AGENDA
PLANNING & ZONING COMMISSION
THURSDAY, October 10, 2019
7:00 P.M. TOWN HALL

TITLE: Sopris Lofts – 1201 Colorado Avenue
Major Site Plan Review and Conditional Use Permit

SOPRIS LOFTS

TITLE	UTILITY PLAN
DRAWING NO.	C-3.0

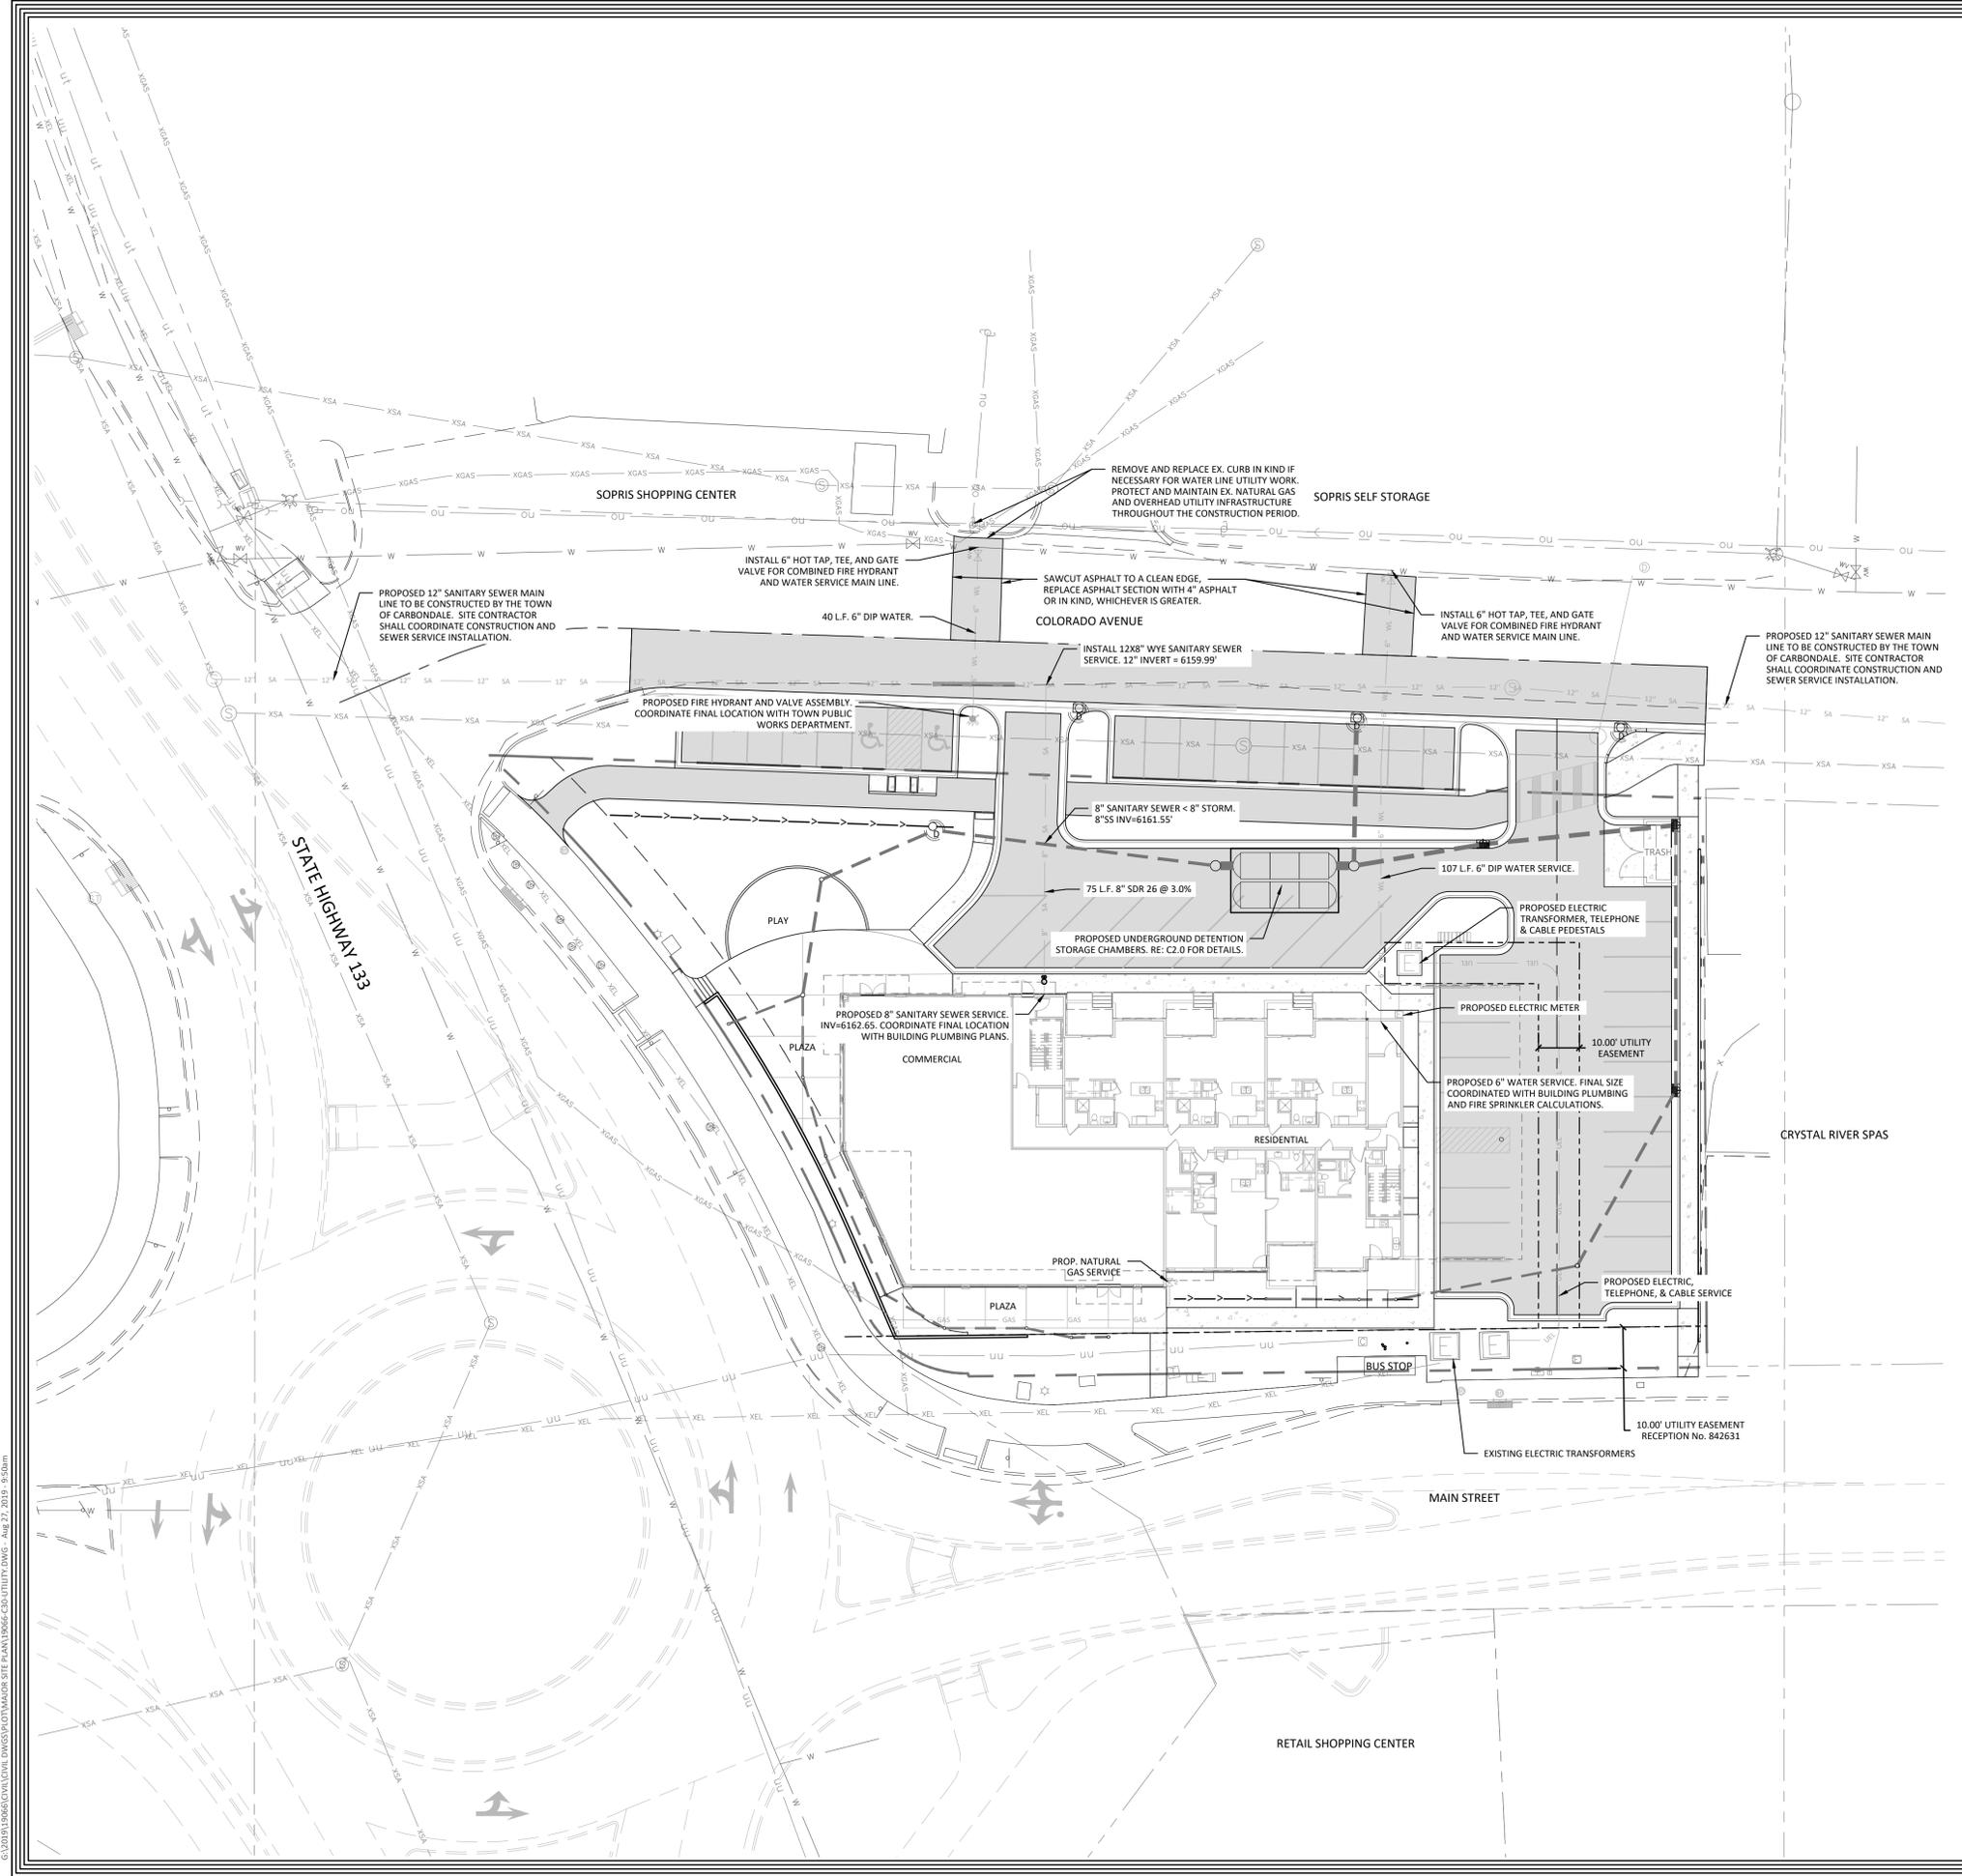
- C-3.0: Note on westerly 6" hot tap indicates that it is for a hydrant/service line, but the plan looks like it is just a hydrant tap. Please clarify.
- C-3.0: Note on easterly 6" hot tap indicates that it is for a hydrant/service line, but the plan looks like it is just a service line. Please clarify.
- Final plans should include a detail for water line protection where the sewer crosses the new water lines.

- C-3.0: Sewer connection is proposed to be a 12x8 wye. Consider installation of a manhole rather than a wye for this size of connection.
- Final plans should include a cleanout outside of the building.

TITLE	SITE PLAN
DRAWING NO.	C-1.0

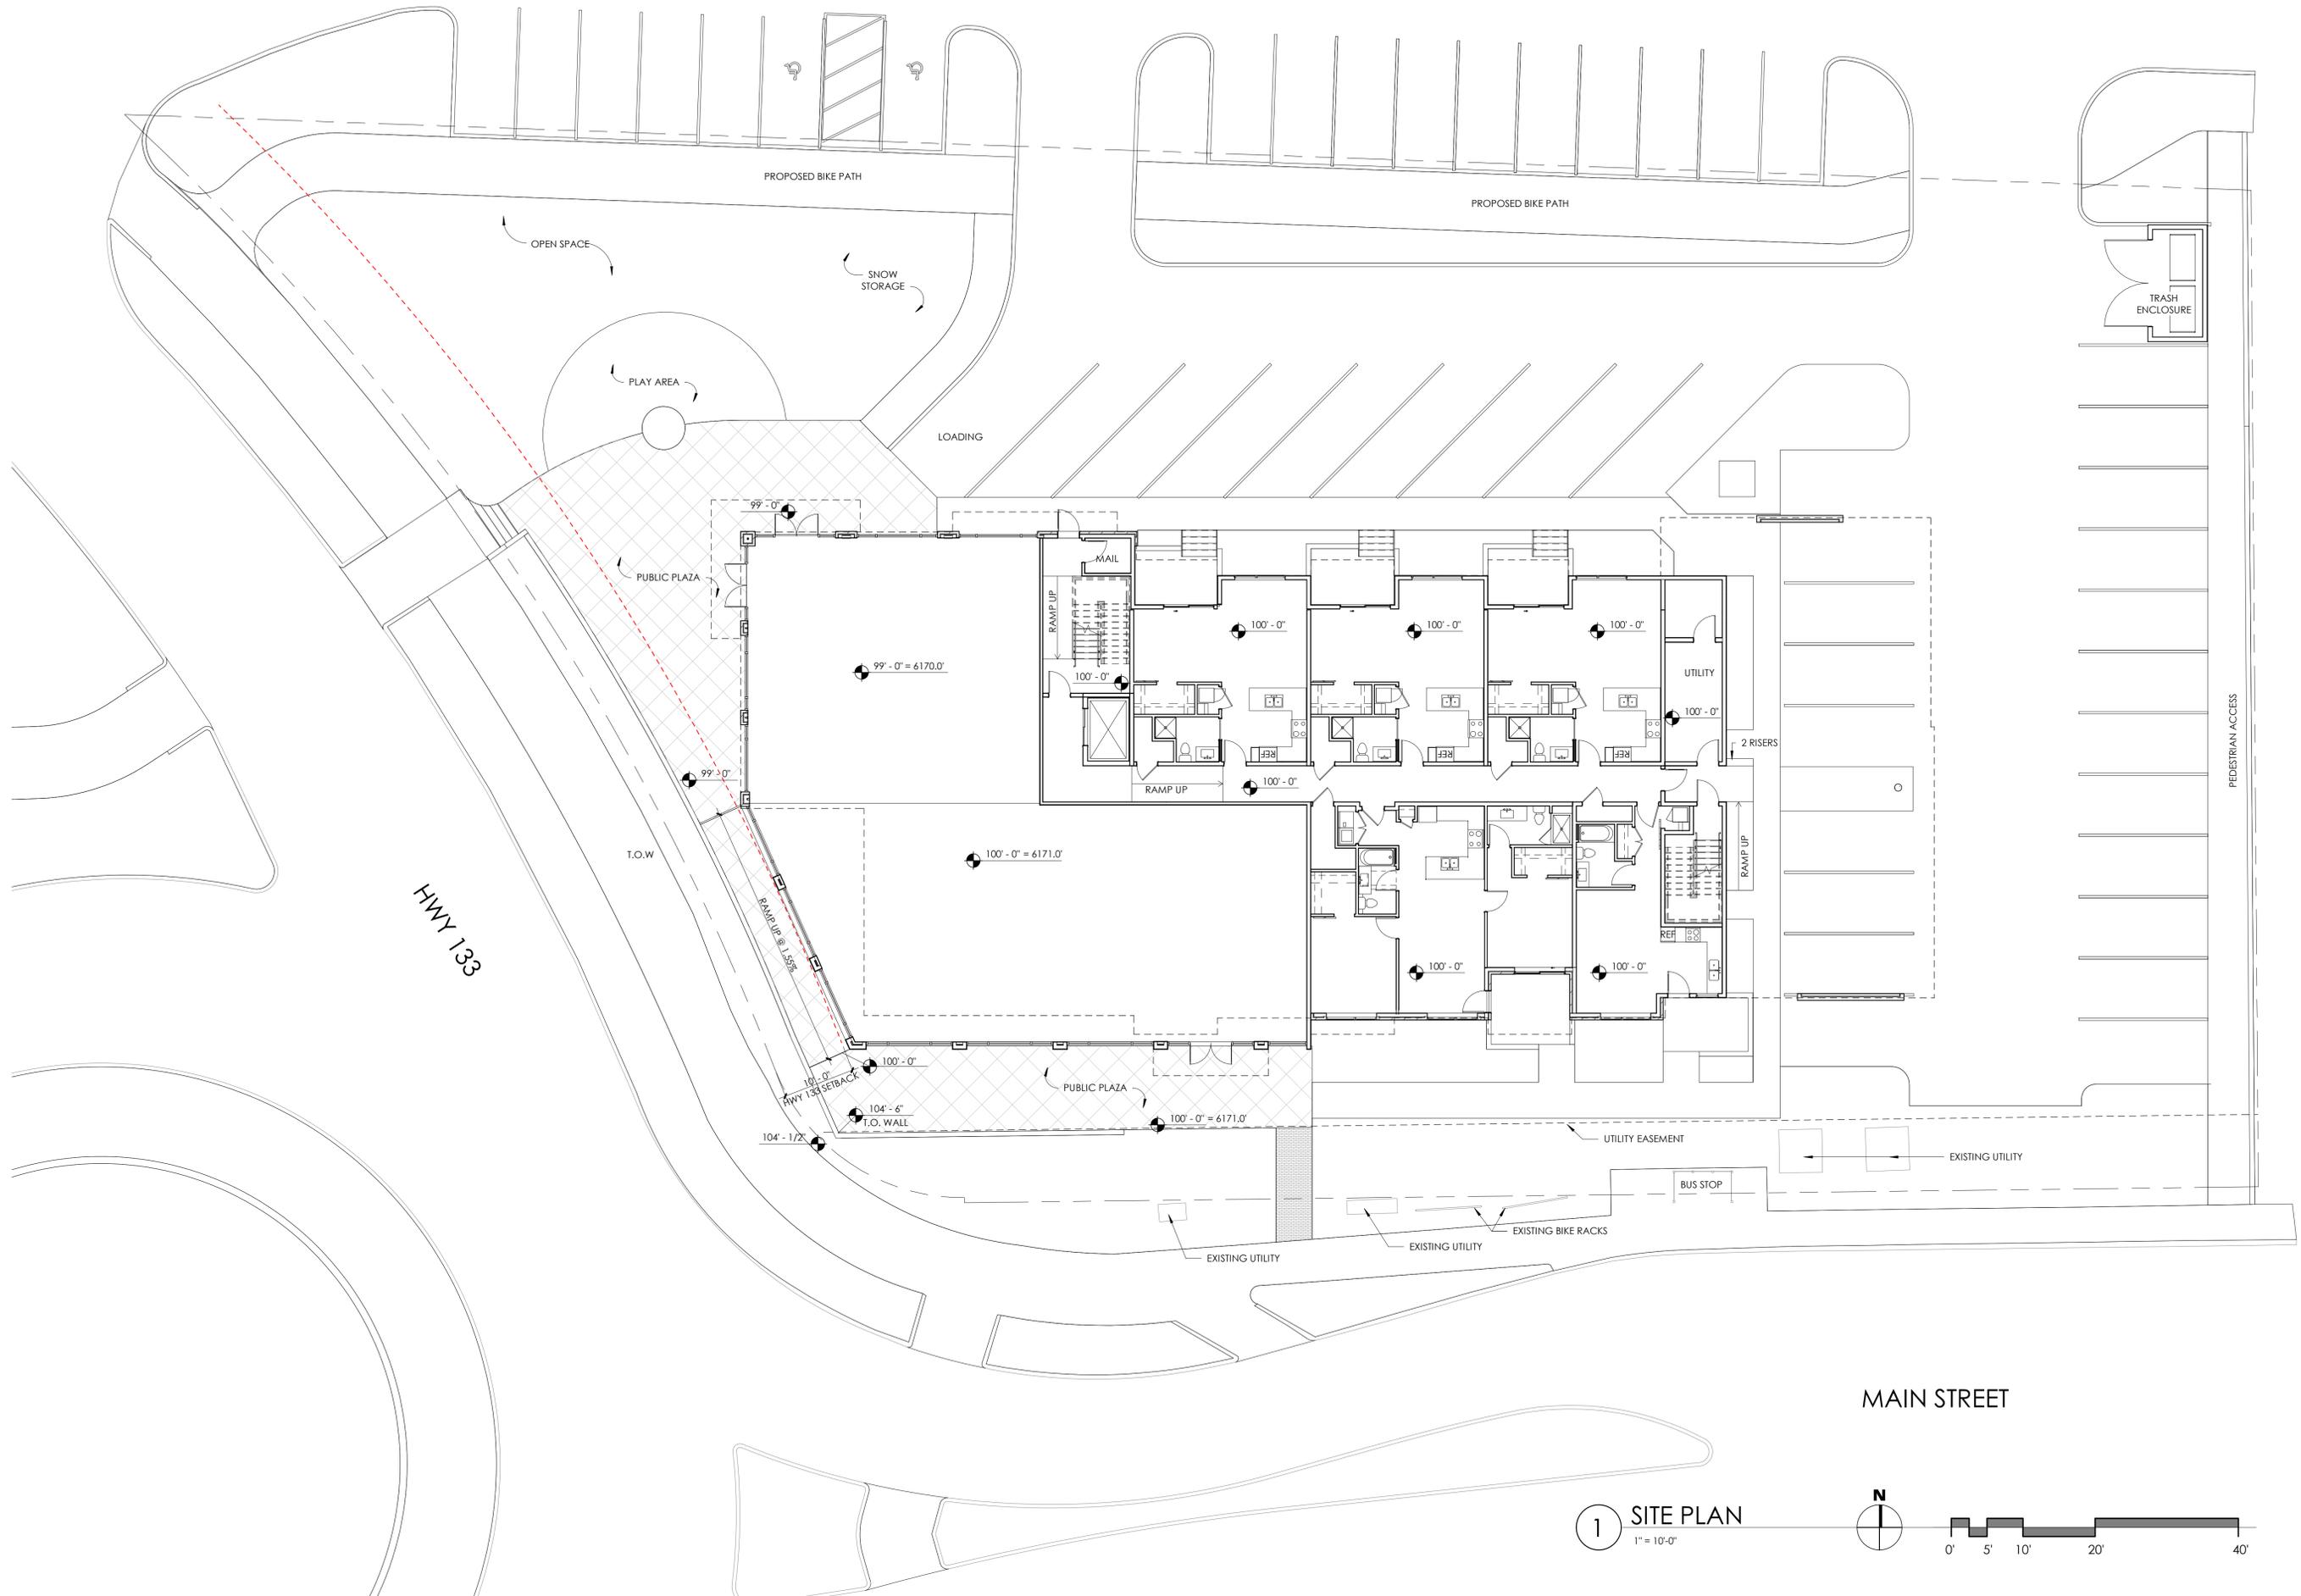
The site plan shows a 5 ft. wide bicycle/pedestrian on the east side of the property between Main Street and Colorado Avenue. The applicant has offered that this can be used by the public. This is a valuable corridor to allow people getting off at the bus stop to walk or bike to the north. There will need to be a public access easement as part of the approval. In addition, it is important that this pathway be well lit.

UDC Section 5.5.3.B.2. requires a pedestrian crosswalk from the northeast corner of the building to the easterly drive. This should be included on the site plan.

- The only snow storage is shown in the open space near the play area. This area is less than 30 feet wide and the landscape plan shows a tree in the middle of it. Is all of the snow from the entire site going to be plowed/hailed to this area? If so, it does not appear to be large enough. Please provide calculations that confirm that this area is large enough to accommodate all of the snow from the entire site.
